REPORT OF: URBAN DESIGN COMMISSION

TITLE: 5115 University Avenue – PUD(GDP-SIP) for a Mixed-Use Development in UDD No. 6. 19th Ald. Dist. (23464)

SUBJECT: **5063-5119 University Avenue & 702 N. Whitney Way – Rezoning– C3 to PUD (GDP) / Demolition of 11 commercial buildings; GDP for construction of mixed-use development; SIP for medical clinic; Preliminary and Final Plat of University Crossing**

**ADDENDUM TO TRAFFIC STUDY - UNIVERSITY CROSSING
UNIVERSITY AVE – WHITNEY WAY INTERSECTION
City of Madison, WI
Prepared by Mary Greuel, KL Engineering
September 13, 2011**

4.3 CONCEPT MASTER PLAN

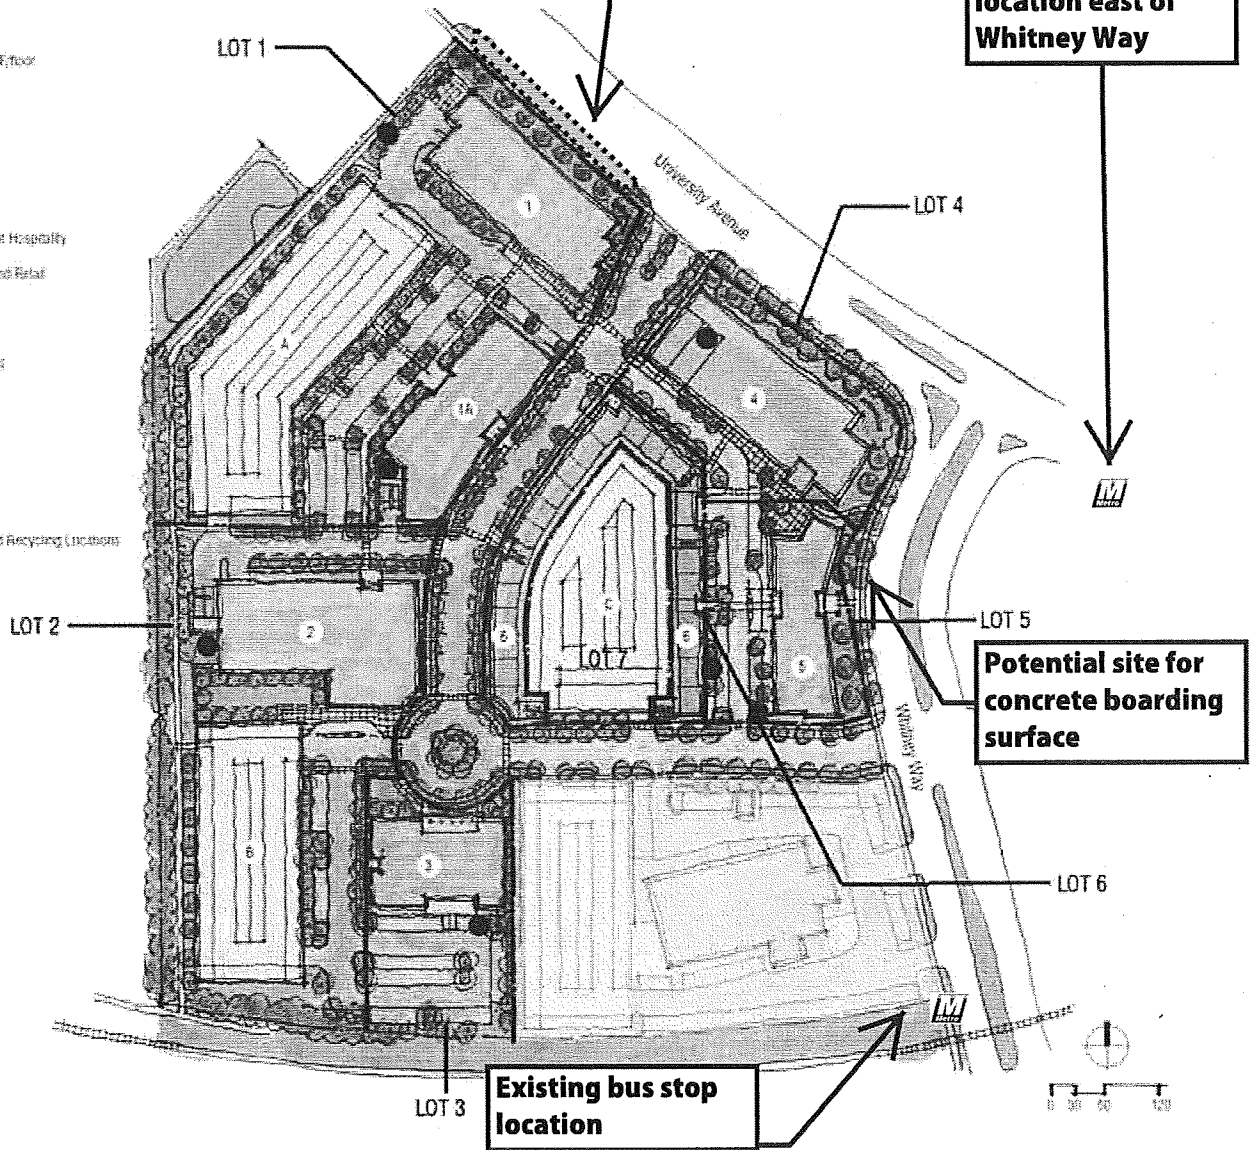
Planned bus stop location opposite Flambeau Road intersection.

Area of potential bus stop pullout lane, and passenger amenities, for new bus stop location.

Planned bus stop location east of Whitney Way

UNIVERSITY CROSSING - HALF SIGNAL GEOMETRY

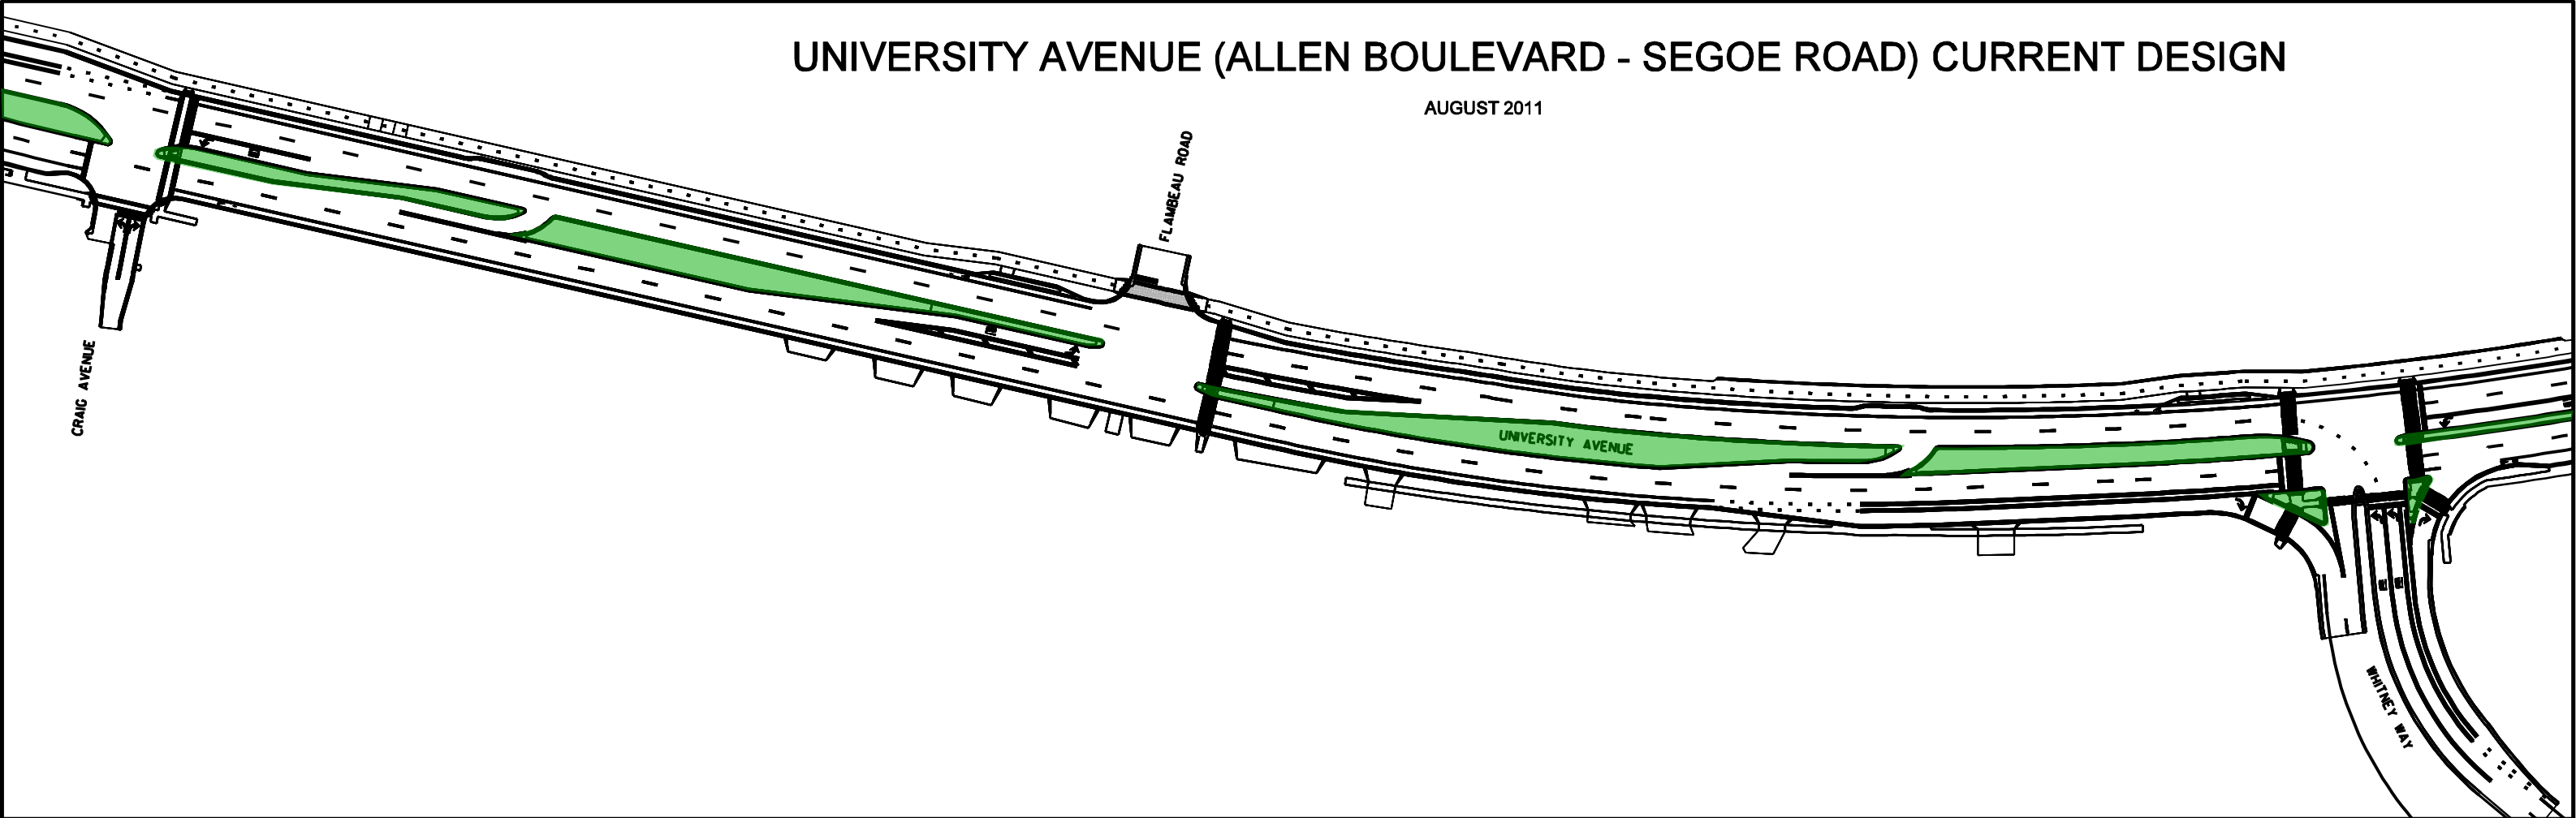
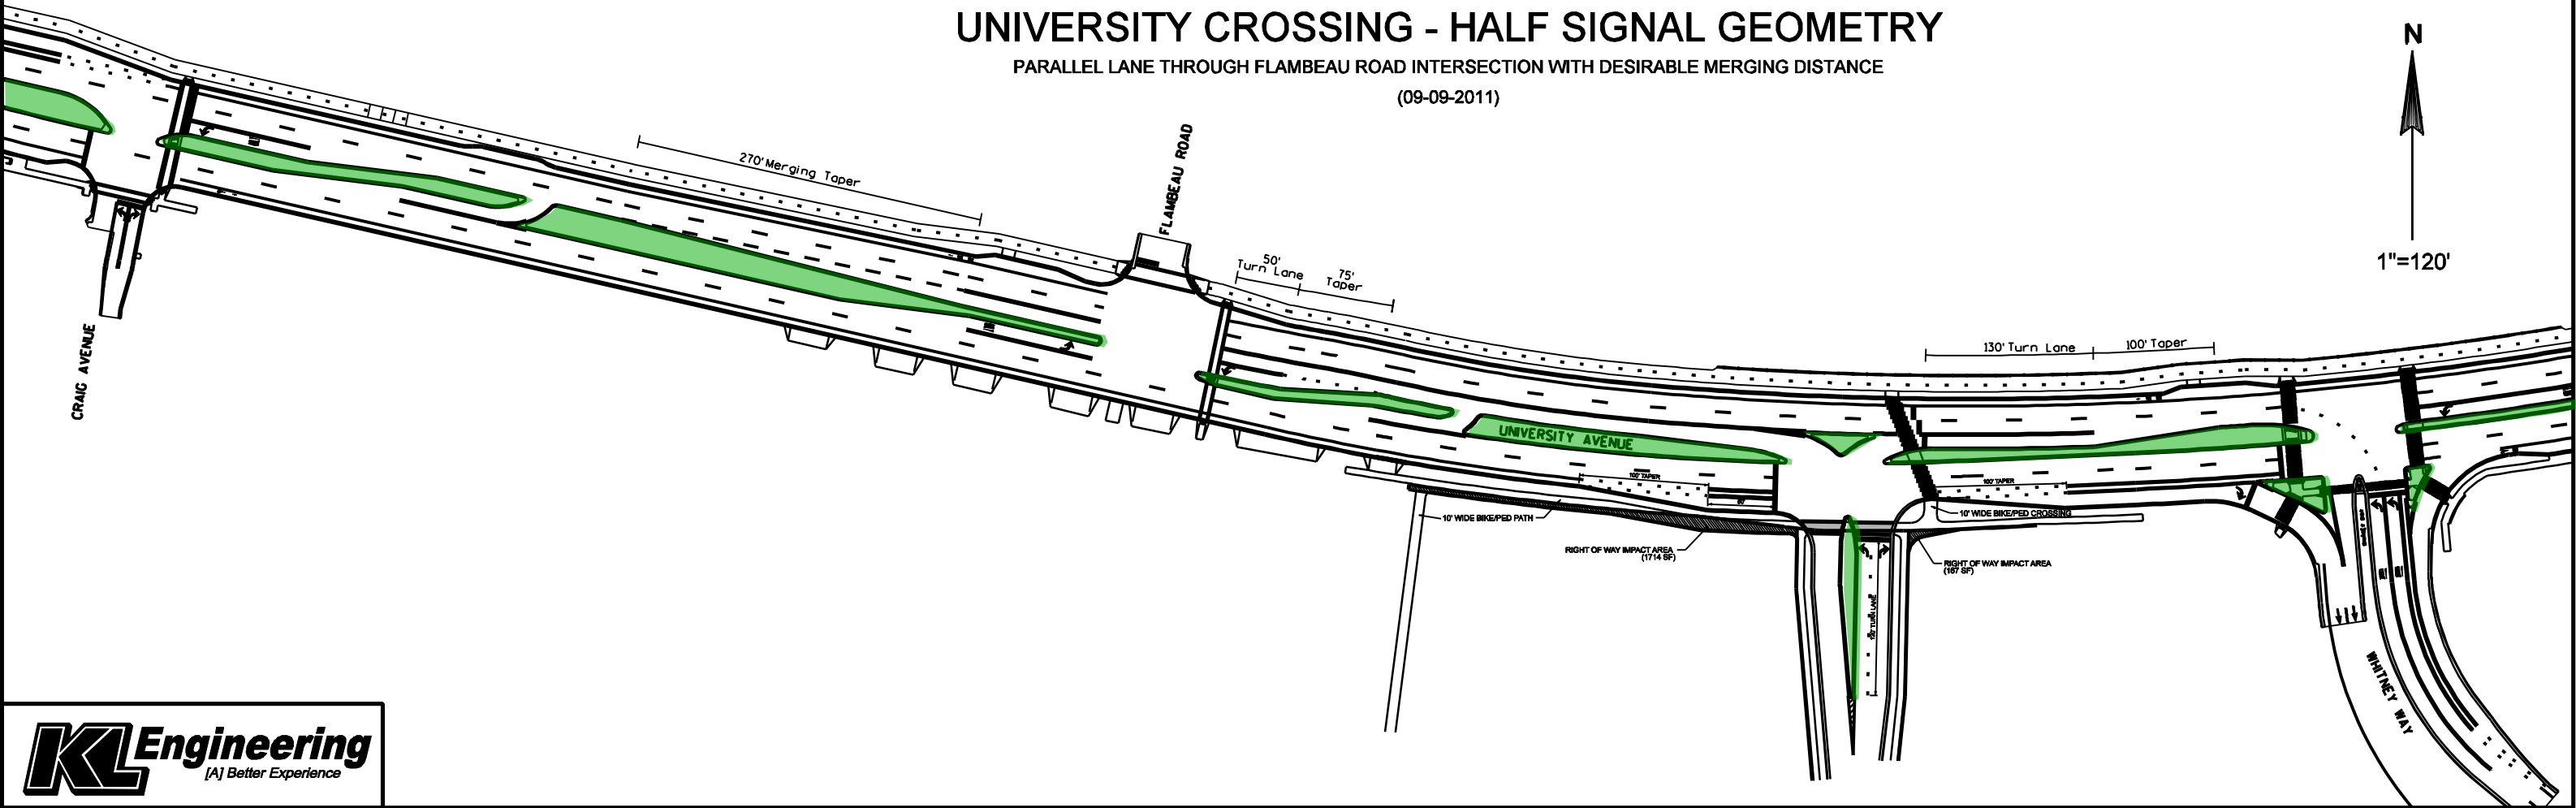
At the request of the City of Madison Traffic Engineering Department a modified version of a “half” traffic signal at the proposed intersection of University Avenue and University Crossing was evaluated. The City prefers a “half” traffic signal to a full signal because they prefer to avoid stopping outbound University Avenue.

The concern with the half signal as discussed in the traffic study includes the short distance allowed for the merge with minimal gaps in traffic, specifically during PM peak hours. Although this might be feasible in the short term, as traffic volumes on University Avenue and Whitney Way increase, the merge would become increasingly difficult and could result in a back up of traffic in the merging area. Additionally, because the merging area is so close to the University Avenue – Whitney Way intersection, vehicles arriving in queues from the east on University Avenue and from Whitney Way will still be tightly packed resulting in merging being difficult during some time periods of the day. To alleviate some of these issues, a long term option was suggested by the City of Madison which includes a “half” traffic signal with a third lane added to westbound University Avenue through the Flambeau intersection.

The new proposed “half” signal option includes the third lane westbound which is added at the development access point and continues as a full eleven foot lane through the Flambeau Road intersection. This third lane would then merge into the other two lanes of westbound University Avenue between Flambeau and the U turn bay east of Craig Avenue. This design results in approximately five additional feet of total street width. The eleven feet required is taken from the median and by relocating the north curb line of University Avenue approximately five feet to the north. This design can be constructed within the existing right-of-way (ROW) with the exception of the additional ROW already required from the developer to build the half signal option discussed in the report.

In comparison to the previous “half” signal proposal, this option results in a longer and therefore safer merge opportunity for traffic exiting the development and eliminates the possibility that traffic attempting to merge will back up through the University Crossing intersection. Because outbound University Avenue and left turning traffic from Whitney Way does not have to stop at the access point, this alternative also results in safer, more efficient movement of traffic for these movements when compared to a full traffic signal. It does require that traffic attempting to left or U turn at the Flambeau Road intersection cross the third lane to enter the westbound turn lane there.

Attached are plan and profile sheets for the modified “half” signal design as well as a schematic showing both the current design for University Avenue and the proposed modified design. Because additional right-of-way is not required to build this design, it is feasible to consider incorporating it into the University Avenue reconstruction project planned for 2012.
